AGENDA
PLANNING COMMISSION
116 WEST NEEDLES
BIXBY, OKLAHOMA
August 17, 2015 6:00 PM

BSP 2015-05 – “Jiffy Lube Office Building” – W Design, LLC (PUD 54)

AS100

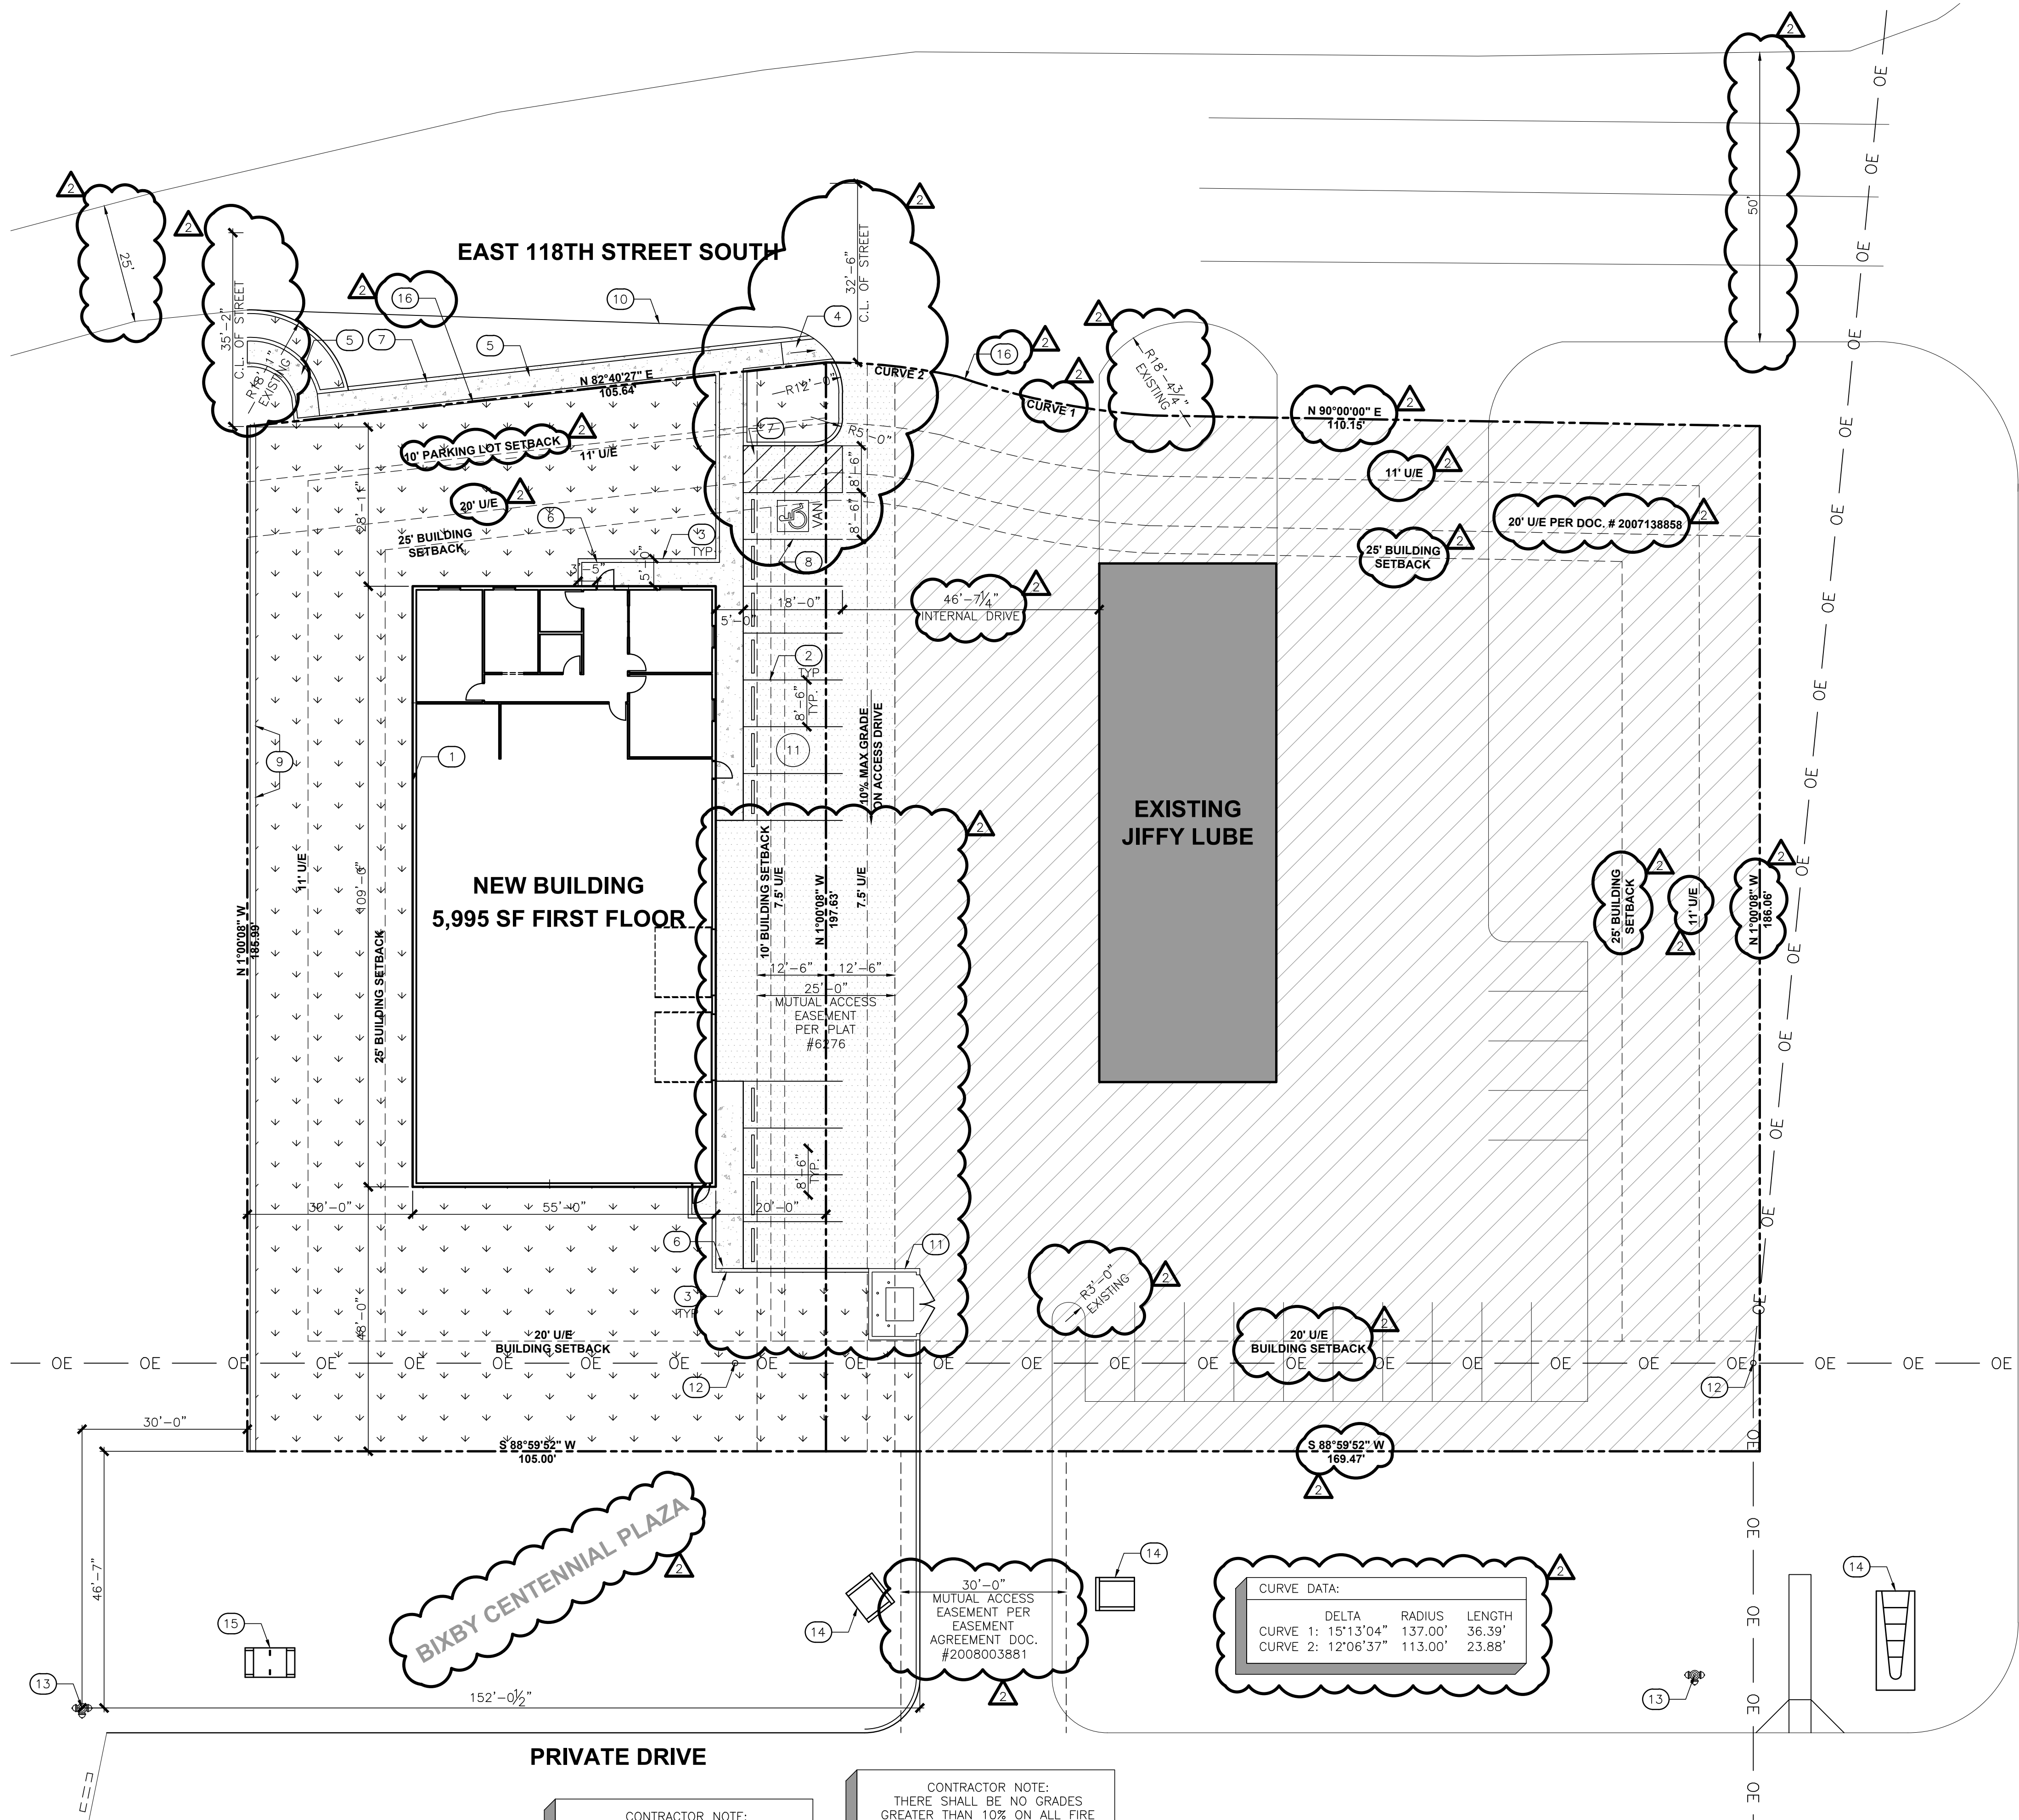
The Detailed Site Plan was prepared by W Design, LLC of Tulsa. The submitted plan-view Site Plan drawing consists of "Architectural Site Plan" drawing AS100 and "Floor Plan First Floor" drawing A201 (hereinafter, individually or together, sometimes "Site Plan" or "site plan"). The landscape plan consists of a "Landscape Plan" drawing AS101. Appearance and height information is provided on the "Exterior Elevations" drawing A301. Fence/screening information is provided by the representation of such information on AS100. The Lighting Plan consists of "Photometric Site Plan" drawing AS102. The application form indicates that the Sign Plan is "N/A." Per a site inspection, there are no signs on site, and no signs are indicated as proposed on any of the drawings; however, see Screening/Fencing and Signage analyses sections of this report.

ADA guidelines require one (1) van-accessible design for the handicapped-accessible space, for up to seven (7) accessible spaces (reference New ADAAG Section 208.2.4, DOJ Section 4.1.2(5)b, and IBC/ANSI Section 1106.5). The Site Plan provides that the one (1) accessible space will be of van-accessible design, and the dimensions provided on the space appear to comply with ADA dimensional standards. The dimensional design standards of per Zoning Code Section 11-10-4.C Figure 3 do not apply to van-accessible spaces. Per the revised site plans received August 13, 2015, the van-accessible space is now to the left of the accessible aisle, allowing for passenger-side convenience, as appropriate.

The site plan identifies one (1) trash can enclosure area, which has been relocated with the latest site plans to the southeast corner of the building, which new location also complies with the locational restriction of the PUD. The revised plans call for it to be an 8’-high cedar wood dumpster enclosure, and the profile view/elevation is indicated as diagram #s 4 and 5 on drawings AS101, and appears to demonstrate compliance with the opacity requirement. As recommended, the screening height and composition details have been submitted, for the Planning Commission’s review and approval as a part of this Detailed Site Plan.

1 LANDSCAPE / IRRIGATION PLAN

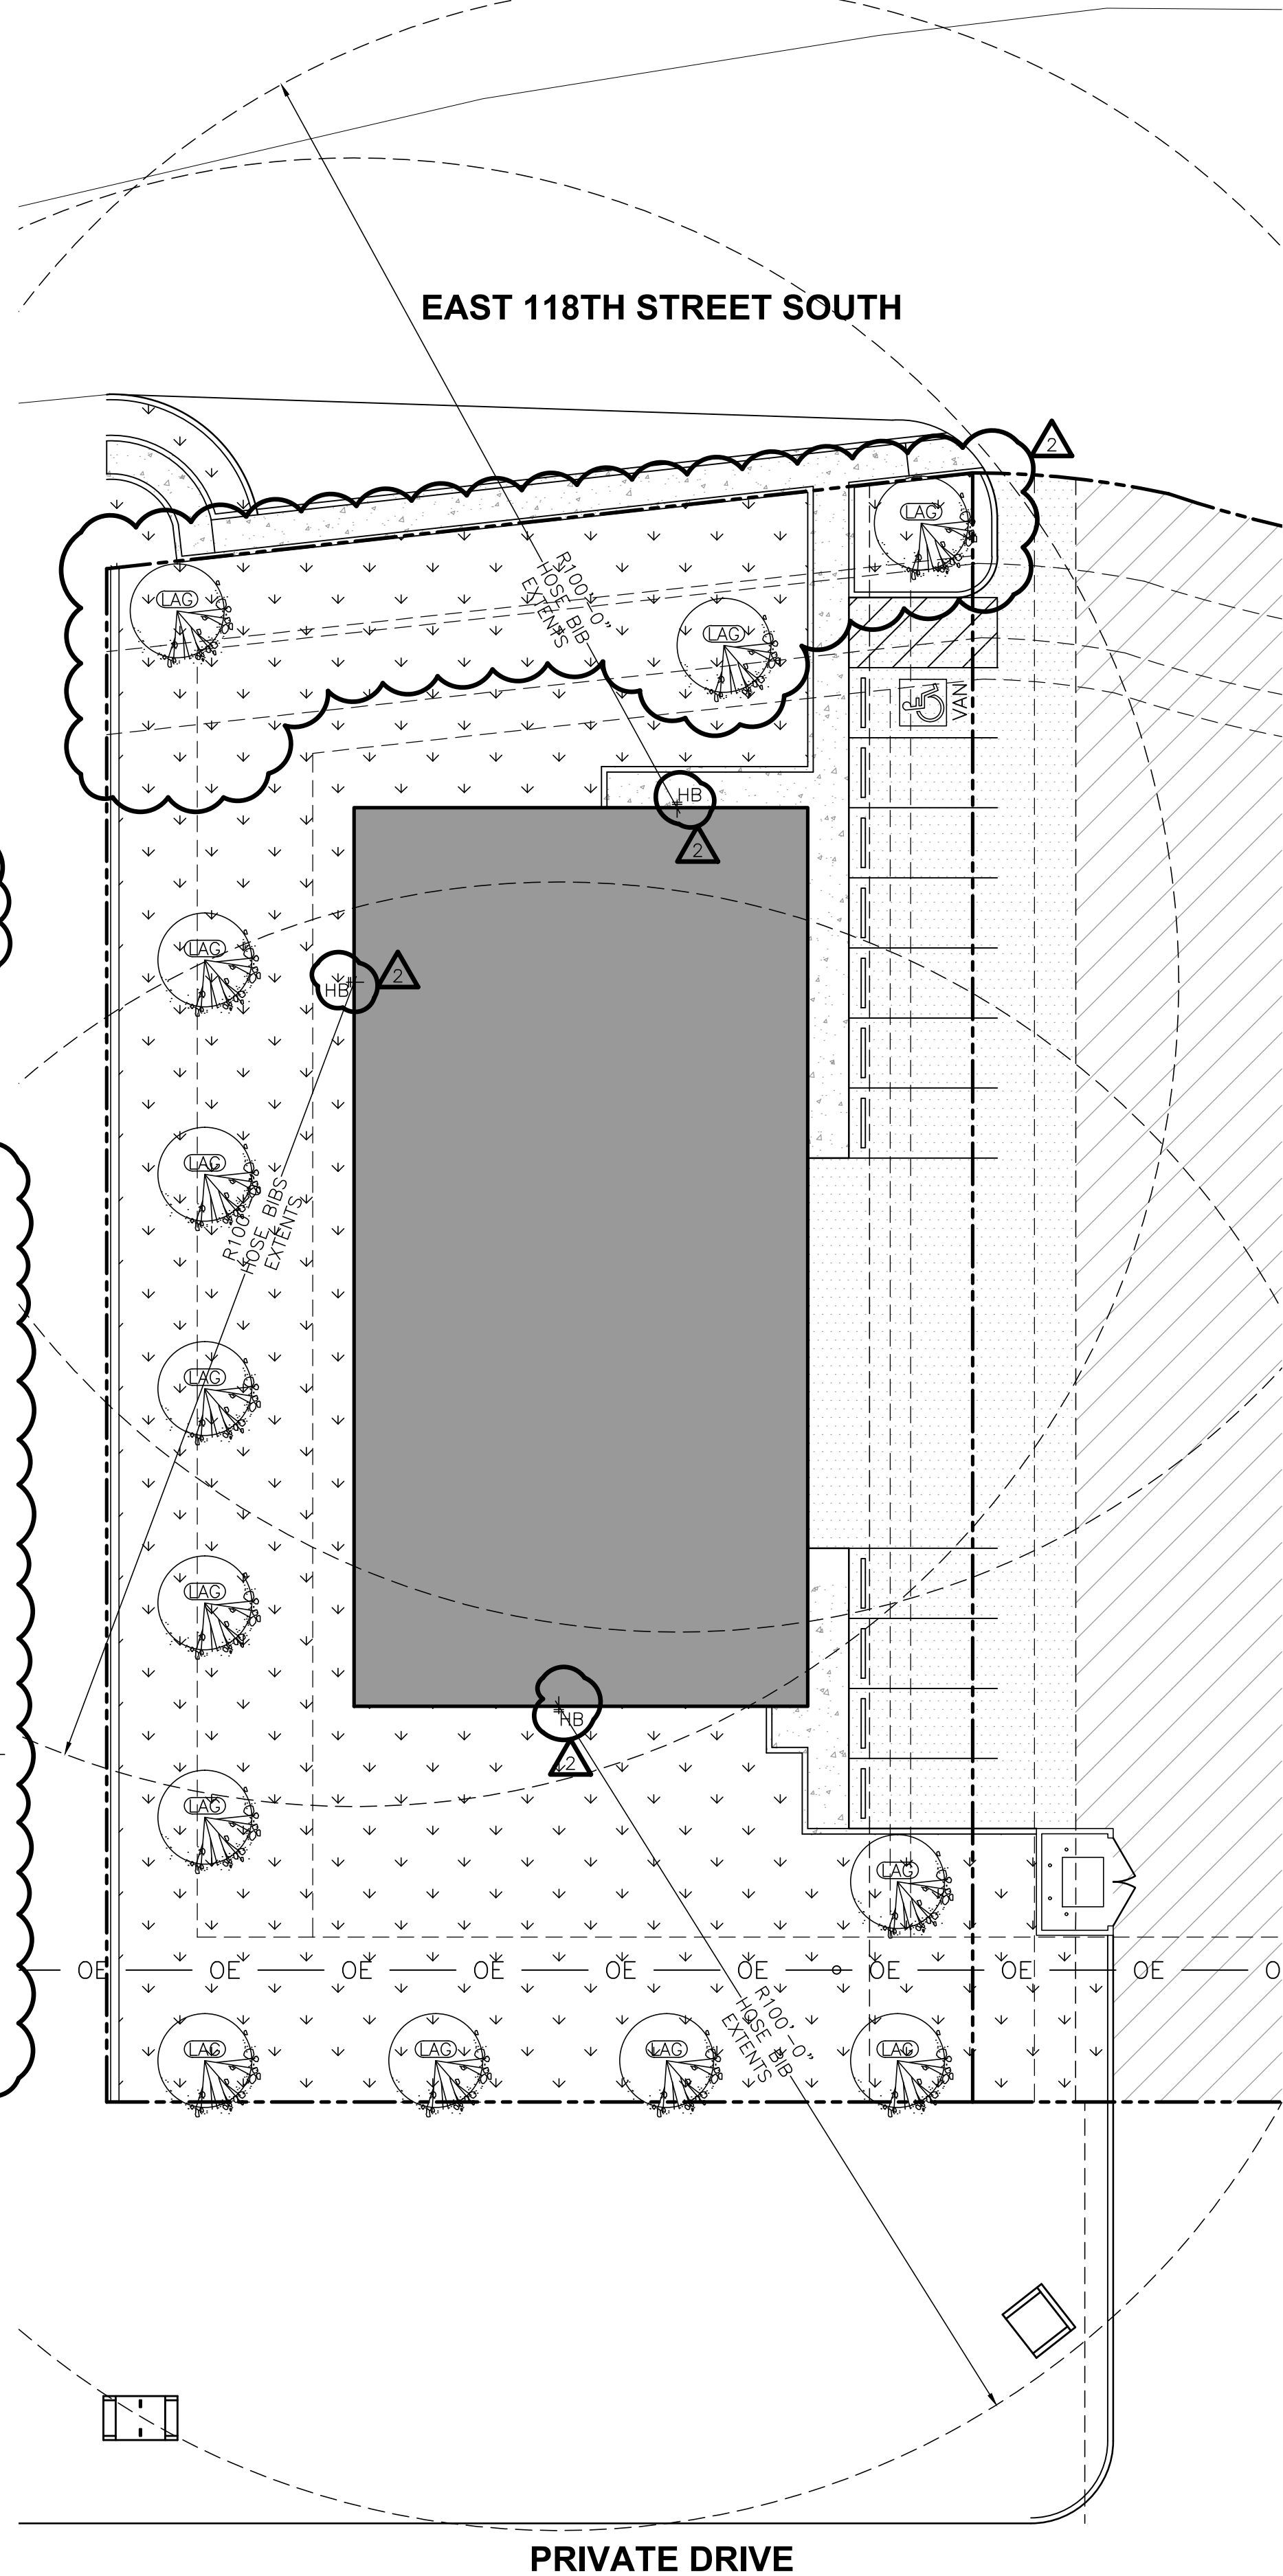
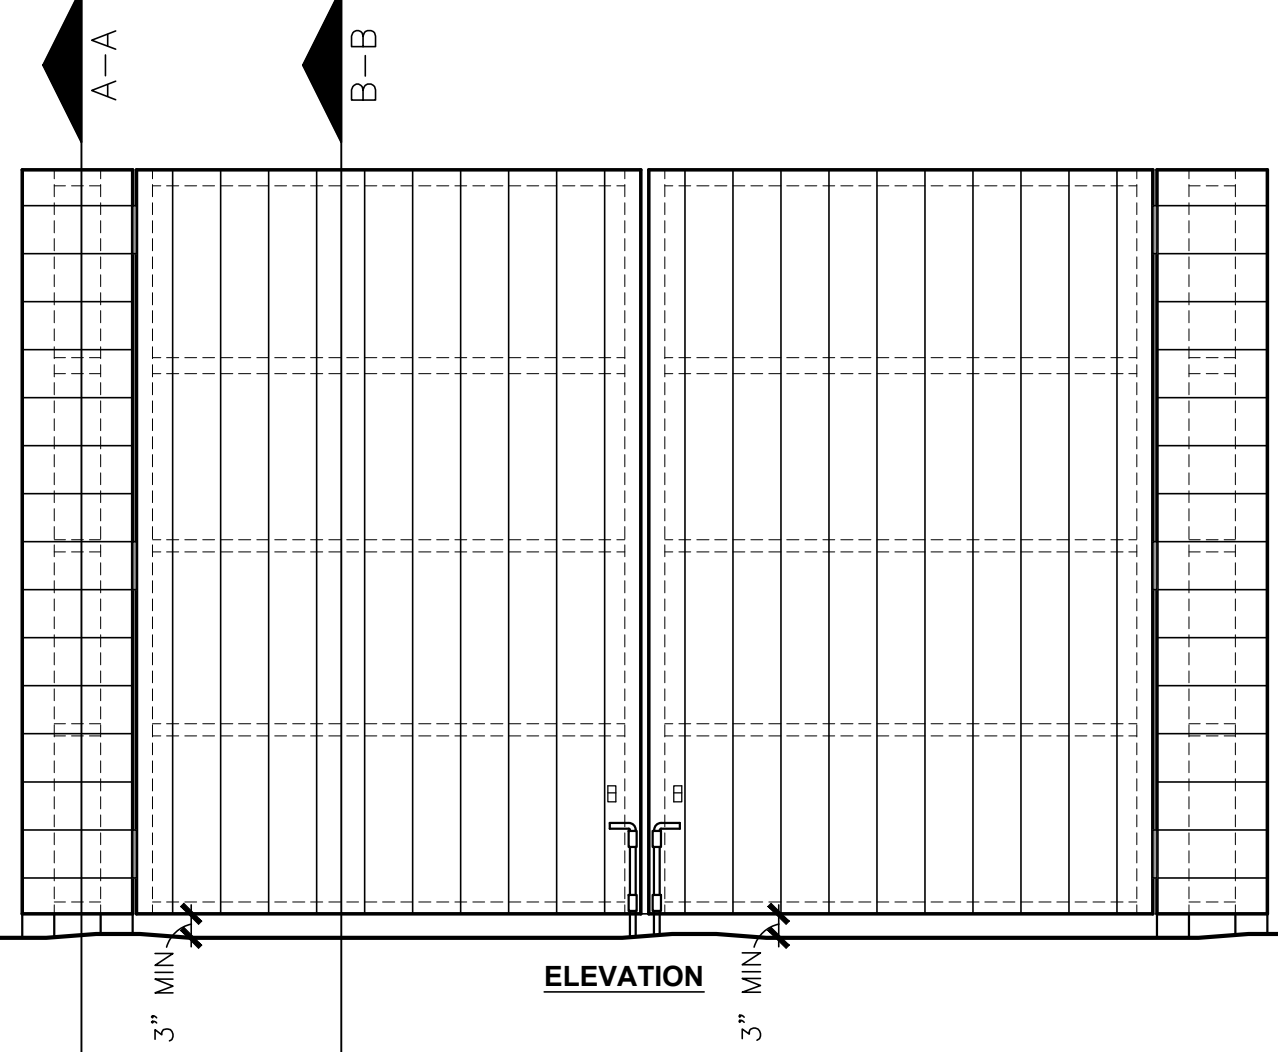
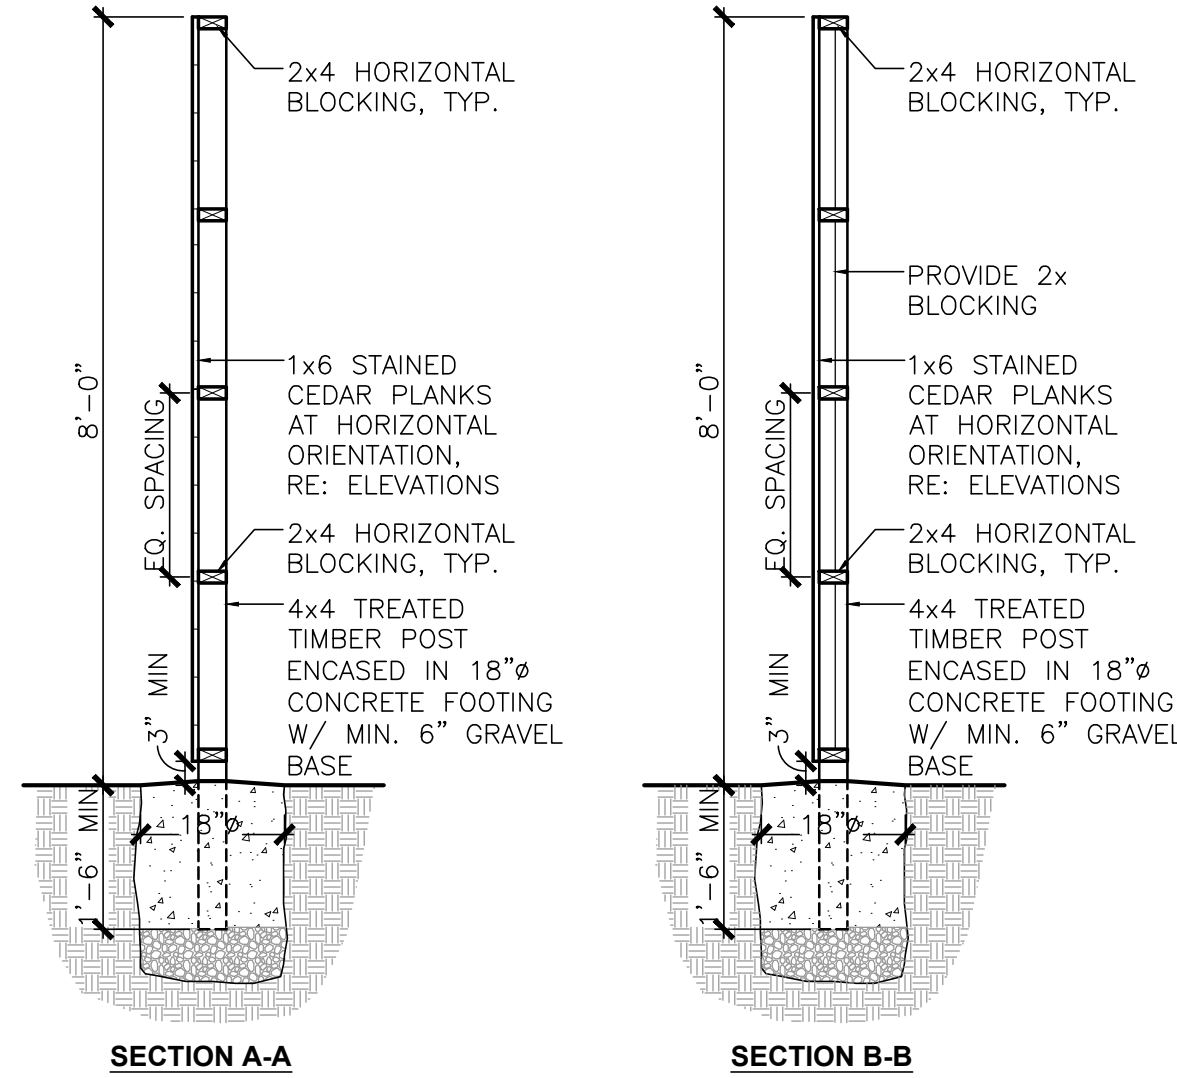
Included		Submittal Items	Comments
Yes	N/A		
☒	☐	Site plan showing the information listed above	
☒	☐	A landscape plan representing all existing and/or proposed landscaping.	
☐	☒	A sign plan representing all existing and/or proposed signs.	
☒	☐	Building elevations or building height information.	
☒	☐	A screening and fence plan or representation on another drawing of all existing and/or proposed fences, walls, gates, and trash receptacle screening enclosures.	EXISTING FENCE SHOWN ON THE SHEET 2/A5100
☒	☐	A lighting plan and lighting information.
